March 10, 2017

**Subject:** **URGENT MEDICAL DEVICE REMOVAL – LOT SPECIFIC**

**Affected Product:** iASSIST Validation Tool

<p>Validation tool 20-8011-021-00 Rev M-P</p> <p><b>Affected by the field action</b></p>		
--	--	---

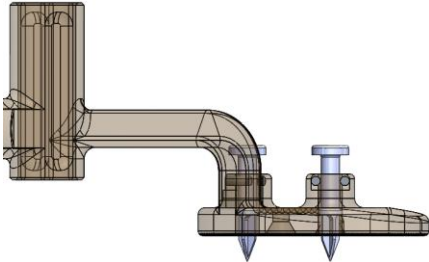
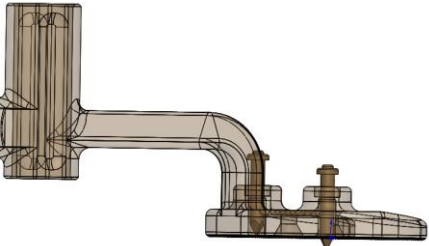
Zimmer Biomet is conducting a medical device field removal for the iASSIST Validation Tool. There has been an increase in the number of complaints regarding bent or broken Drive Pins of the Validation Tool manufactured with drawing Revision M to P, see red box below.

**Affected drawing Revision M to P of Drive Pin:**

**Unaffected drawing Revision R and drawing Revision L of Drive Pin:**

<p>Validation tool 20-8011-021-00 Rev R</p> <p><b>Not affected by the field action</b></p>		
<p>Validation tool 20-8011-021-00 Rev L</p> <p><b>Not affected by the field action</b></p>

As indicated in the pictures above, drawing revision M to P of the Drive Pins has an X cross section instead of circular. Also, the Drive Pin head has a recess in the enlarged head. Only iASSIST Validation Tools with drawing revision M to P Drive Pins, in the red box above, are affected by this field removal.
